PLANNING COMMISSION AGENDA REPORT

SUBJECT: Review of a 31,250-square foot operation, administration and maintenance facility for the Regional Transit Authority (RTA), including a request for a fence height exception to allow a fence of a maximum of 8 feet where a range of heights from 3 to 6 feet is the standard maximum.

PROJECT ADDRESS: 253 Elks Lane

FILE NUMBER: ARCH-0200-2019 & EID-0201-2019

- NOTES:**
1. SECURITY FENCING TO BE TYPICALLY 8' TALL ANTI-CLIMB, BLACK COATED FENCING.
 2. SEE SHEETS 06 AND 07 FOR LANDSCAPE AREAS AND PLANTING DESIGNATIONS.
 3. SEE SHEET 08 FOR REFERENCE TO SECTION LOCATIONS.
 4. SEE SHEET 09 FOR PLANTING LEGEND.

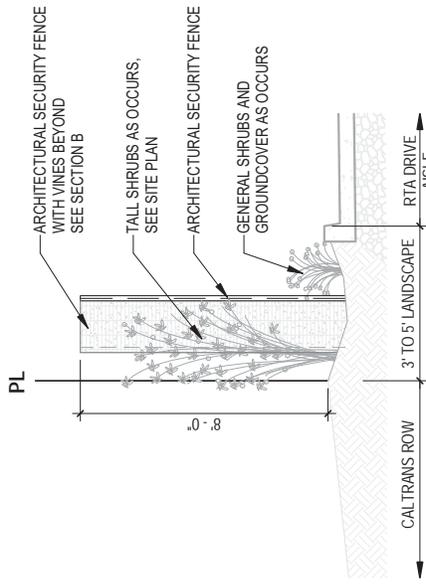
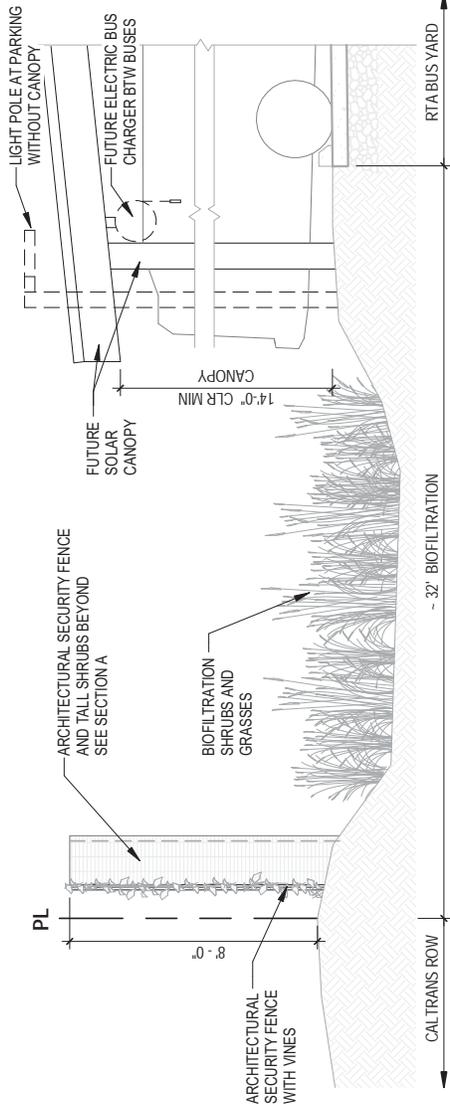
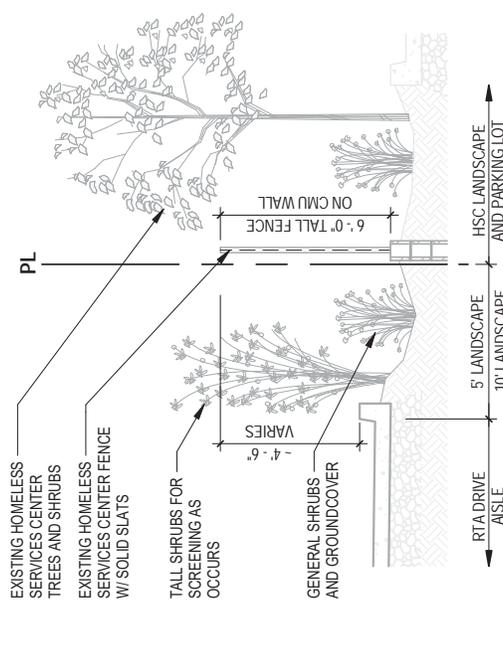
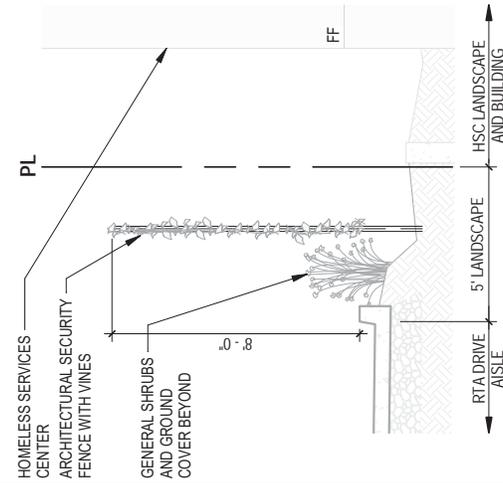
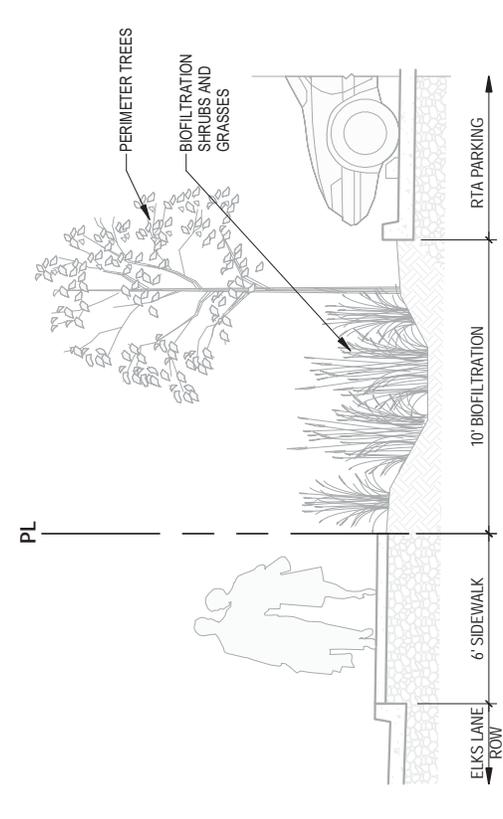
- Review fencing details design to ensure adequate security and address visual impacts per Community Design Guidelines 3.3 F-3 and 3.3 F-5.
- Revise Colors: Metal siding colors should be more muted and more closely match the corresponding block color.

Response: The applicant has updated the plans to include better illustrations of the proposed fencing (Figure 1, and Attachment 2, Project Plans, Sheet 11) and has changed the linear line of the fence to include indentations to allow landscaping (Figure 2). The proposed change is consistent with CDG 3.3 F-3 which states “*Long expanses of fence or wall surfaces should be offset and architecturally designed to prevent monotony. Landscape pockets should be provided along the wall.*” The proposed fencing is specifically designed for sturdiness and security, while also designed to fade into the landscape, reducing the appearance of the fence being a single material (CDG 3.3 F-5).
